# RECOMMENDED SERVICE BULLETIN

## RSB 42-125

## RSB 42NG-065

Replacement of steel pin of door handle mechanism of canopy and passenger door with an improved design.

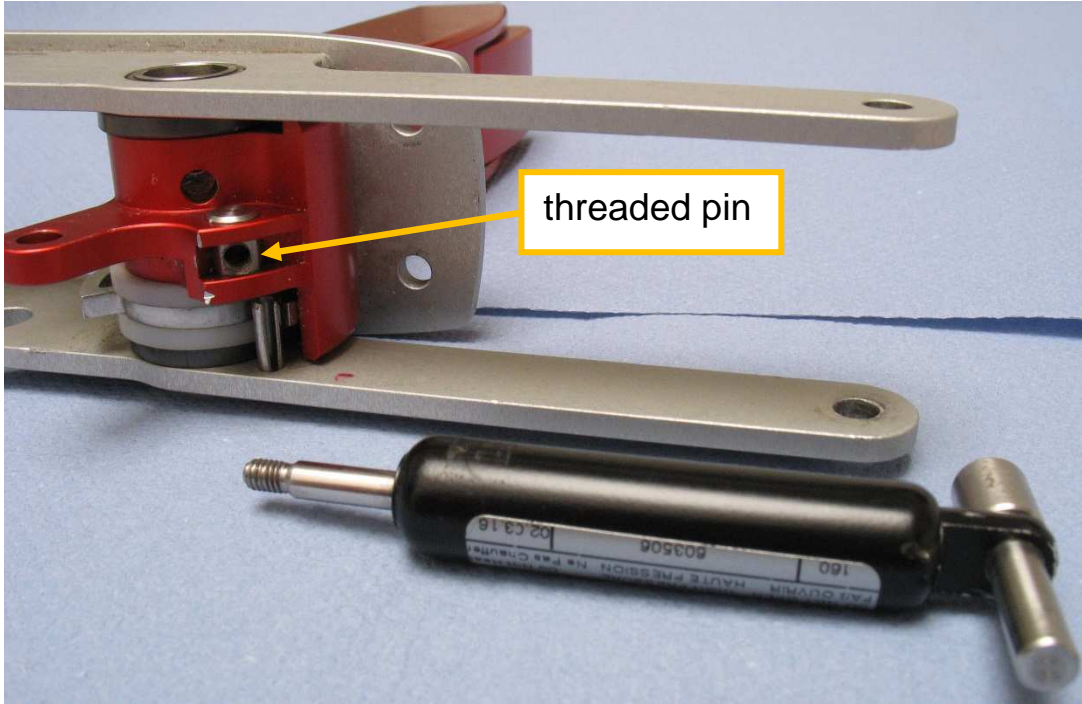
1	Make sure that AMM-TR-MÄM 42-994 has been incorporated into the AMM.
2	Test the compression gas spring of the passenger door in accordance with AMM, section 52-10.
3	Remove the door handle mechanism from the passenger door in accordance with AMM, section 52-10.
4	Remove the 2 circlips as shown in the pictures blow. 
5	Remove the steel pin, the polyamide distance bush and the polyamide washer from the door handle mechanism frame.

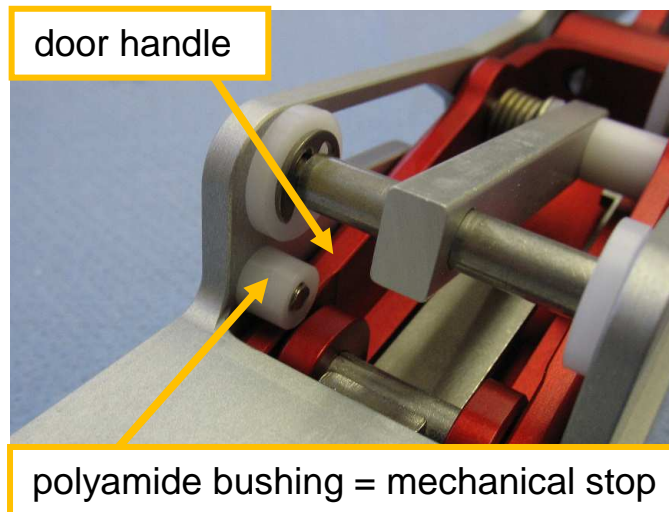
Adjust the length of the compression gas spring. Make sure that the polyamide bushing defines the mechanical stop of the red aluminum door handle as shown in the picture below.

Note: The mechanical stop of the red aluminum door handle must not be defined by the internal stop of the compression gas spring.

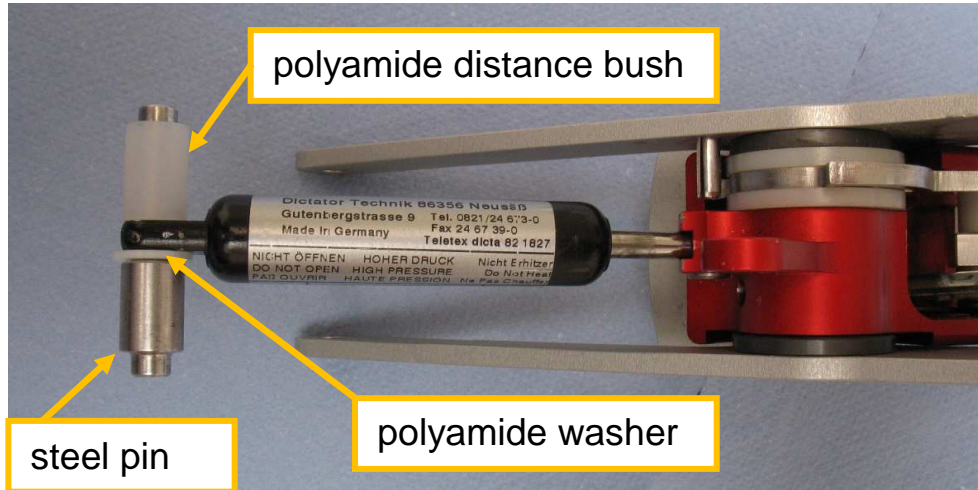
Prepare the new steel pin for installation into the door handle mechanism frame:

- Move the polyamide washer onto the new steel pin.
- Move the steel pin through the eye end of the compression gas spring.
- Move the polyamide distance bush onto the steel pin.

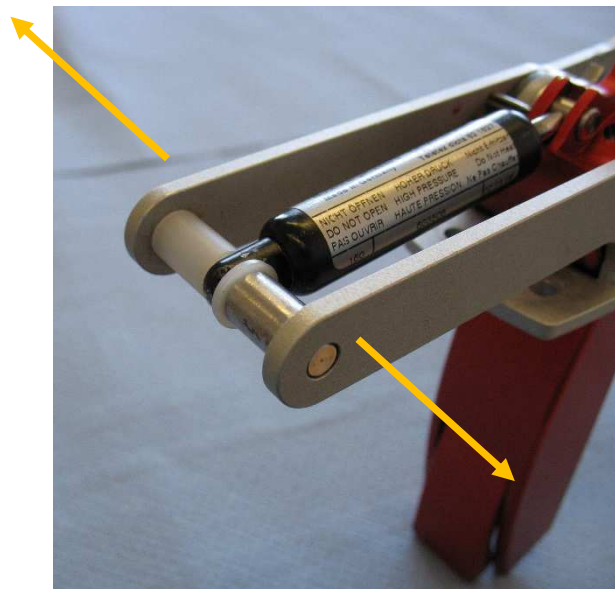
Install the new steel pin with the polyamide washer and the polyamide distance bush to the door handle mechanism frame:

- Move the steel pin into position.
- Carefully bend the side parts of the door handle mechanism frame away from each other as shown by the yellow arrows in the picture below so that the steel pin can snap into the holes of the side parts of the door handle mechanism frame.

**Caution:** Bend the side parts of the door handle mechanism frame away from each other only as far as necessary. If the side parts are bent too much and permanently deformed, the whole door handle mechanism must be replaced.
